Tasman District Council

BC200322

Site Address: 31 Pineview Way, Motueka Valley

Project Description: Addition of bathroom to sleepout

FLOOR PLAN 1:50

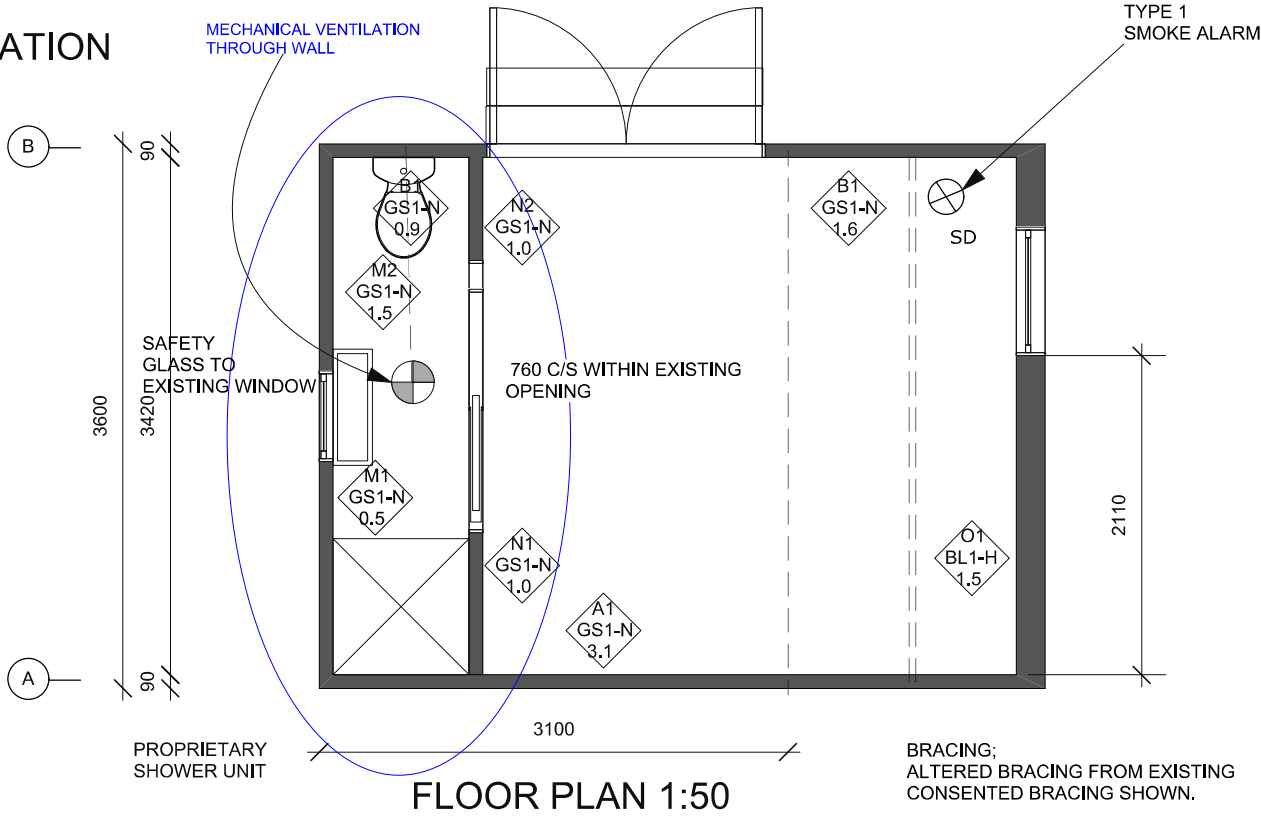
Consent documentation fails to demonstrate this. Please provide information for mechanical extraction to the shower in accordance with the requirements of G4/AS1 section 1.2.5

AMENDED 01.05.2020 VENTILATION TO BATHROOM NOTED
